Determination 2009/8

The code-compliance of a proposed pergola as a barrier for a house located at 190 Huntsbury Avenue, Christchurch

Figure 1 Detail showing the proposed pergola section

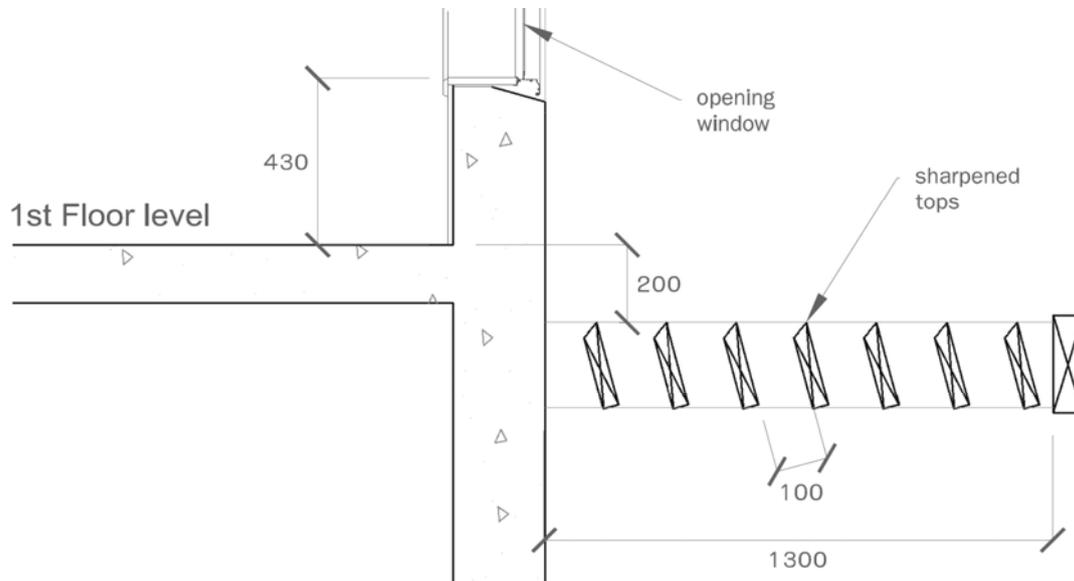
- 2.1 The building work that is the subject of this determination is a proposed cantilevered pergola that is approximately 6.5 metres wide x 1.3 metres long (“the pergola”) that is to be constructed at one elevation of a house. The pergola consists of a galvanised steel frame and inclined timber slats spaced at 100mm centres and bolted to the frame members. The slats are set at an angle and have tapered top edges. The section through the pergola is shown in Figure 1.

- 2.2 The pergola is situated 630mm below the sill of a window that has sliding opening sashes and which is fixed to an upstand wall that has an internal height above the first floor of the building of 430mm. The window provides a maximum opening of 4.5m, the sill itself is 270mm deep.

- 6.4 By itself the upstand is not of an appropriate height for a barrier and does not comply with Clause F4. It is accepted that the upstand falls well sort of the barrier height described in Paragraph 2.0 of F4/AS1.
- 6.5 The upstand is of a height that provides easy access for children under six to climb over, and in my opinion is of a depth that would also allow a child to walk or run along its length. In my opinion the upstand does not comply with the requirement to restrict the passage of children under six.

- The pergola is located along the full length of the upstand.
 - The pergola is 1300 mm wide, compared with the 1500 mm canopy width. In Determination 2008/81, I considered that a landing area 1200 mm wide would provide adequate protection in the case of a fall off a deck. Accordingly, I consider a 1300 mm width to be adequate in this situation.

- The proposed pergola has gaps less than 100mm between the timber slats, and the slats have sharpened top edges that would make them difficult, but not impossible, for anyone to walk across.

- 6.9 An adult who fell onto the pergola is able to return to a position of safety by climbing back over the upstand. The behaviour of children, particularly those under six, may not be as rational as that of an adult in seeking a position of safety, which requires a child to negotiate a height of 630mm and a sill depth of 270mm. In my opinion easy access onto the pergola from the low upstand would put a child in a hazardous position.

- 8.1 In accordance with section 188 of the Act I hereby determine that the proposed combination of the upstand and pergola does not provided a design solution that complies with Clause F4 of the Building Code.

- 7.1 While the Act does not require me to provide a code compliant solution to the parties, in this instance I believe guidance about how compliance might be achieved would be useful.
- 7.2 With the proposed pergola in place, which in my view provides a code compliant solution for adults, a barrier 760mm high, as described in Paragraph 4.0.2(c) of F4/AS1 located in front of the window opening, will provide a code compliant solution for children under the age of six.
- 7.3 Alternatively, and in the absence of the pergola, a barrier fitted to full width of the window of a height described in Table 1 of F4/AS1 would comply with Clause F4.
